ARKANSAS NUCLEAR ONE, UNIT 2

Amendment No. 37  
License No. NPF-6

ATTACHMENT TO LICENSE AMENDMENT NO. 37

SAFETY EVALUATION BY THE OFFICE OF NUCLEAR REACTOR REGULATION  
SUPPORTING AMENDMENT NO. 37 TO FACILITY OPERATING LICENSE NO. NPF-6

FIGURE 3.1-2

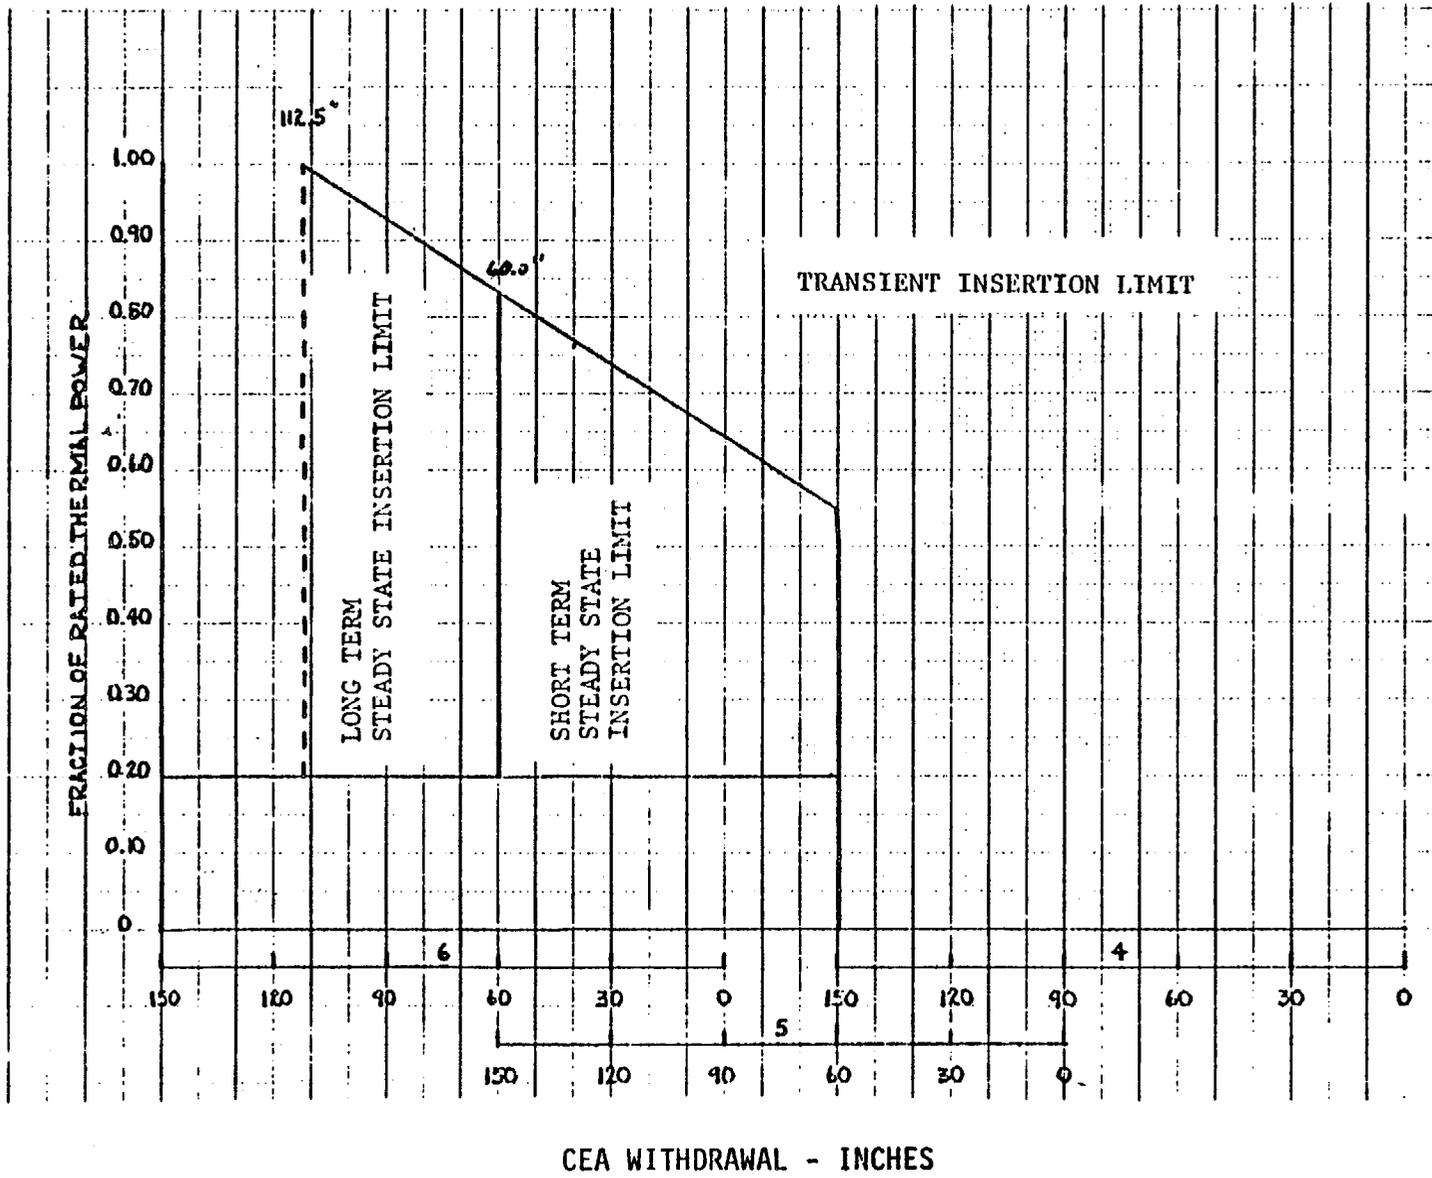
The full length CEA insertion limit curve (Fig. 3.1-2) has been modified so that CEA groups 2, 3, and 4 are fully withdrawn above 20% of rated thermal power. This results in increased shutdown margin due to additional scram worth for low power steam line break events. It also tends to reduce CEA worths and thus mitigates the consequences of Anticipated Operational Occurrences (AOOs), such as the CEA group withdrawal, and of accidents such as the CEA ejection. This modification is, therefore, acceptable.

3.1.3.6 The regulating CEA groups shall be limited to the withdrawal sequence and to the insertion limits shown on Figure 3.1-2 with:

FIGURE 3.1-3  
PART LENGTH CEA INSERTION LIMIT VS. THERMAL POWER

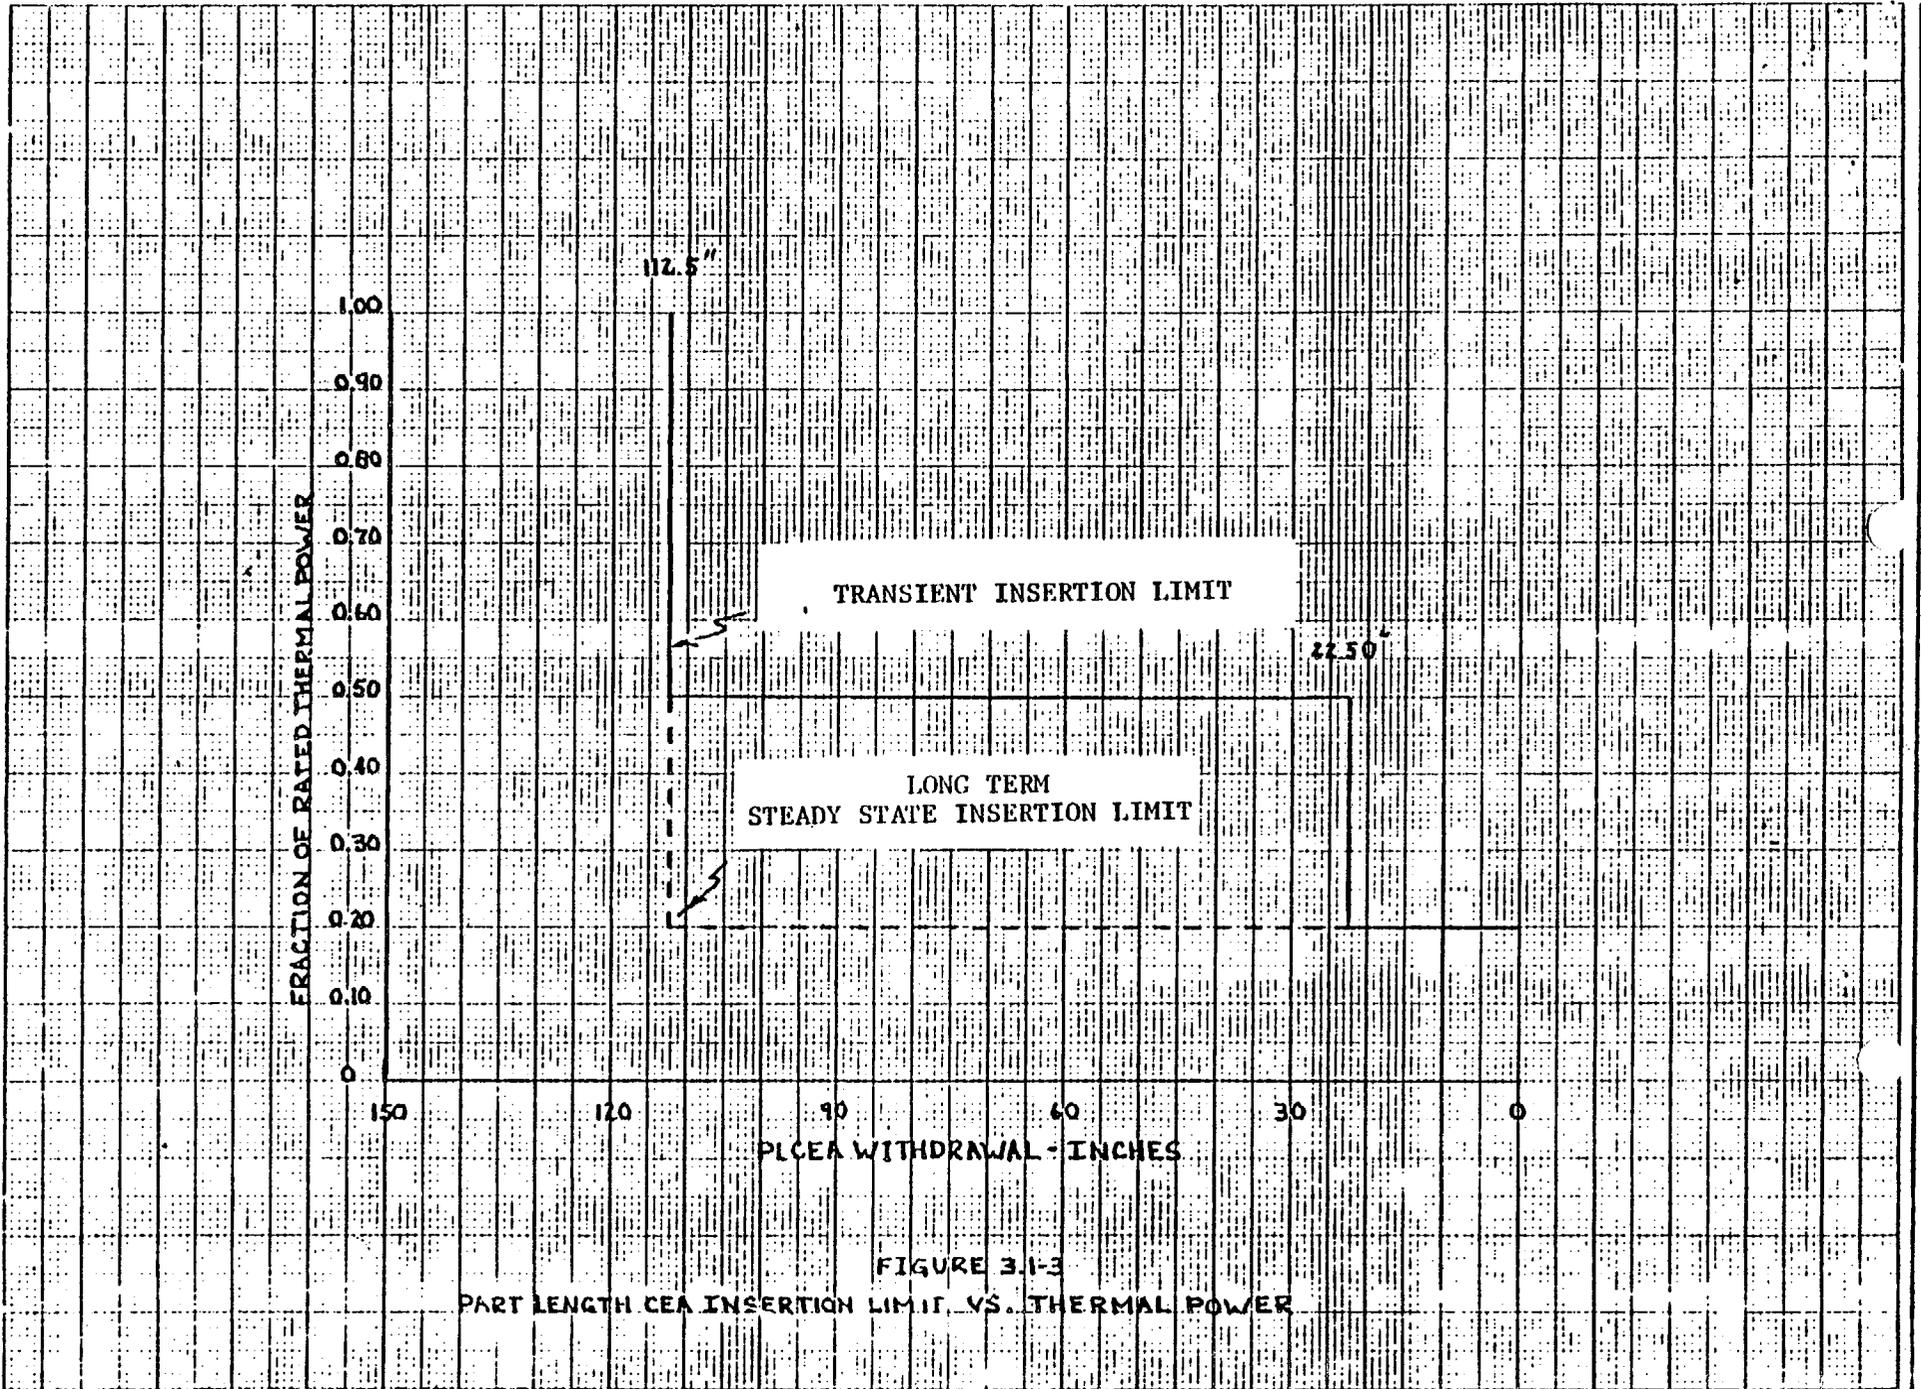
Specification 3.1.3.7 governing the LCO for part length CEA (PLCEA) insertion limits has been added. The specification includes Figure 3.1-3 which gives allowable transient and long term part length CEA insertion limits as a function of thermal power. We find this additional Technical Specification acceptable since it incorporates the CE Standard Technical Specification (STS) LCO restriction on core residence time and ACTION statements as well as the STS surveillance requirements. Also, the insertion limits have been established by previously used and approved methods. In addition, any single PLCEA or PLCEA group drop from the allowable insertion limit is bounded by the ANO-2 FSAR safety analyses.

3.1.3.7 The part length CEA group shall be limited to the insertion limits shown on Figure 3.1-3 with PLCEA insertion between the Long Term Steady State Insertion Limit and the Transient Insertion Limit restricted to:
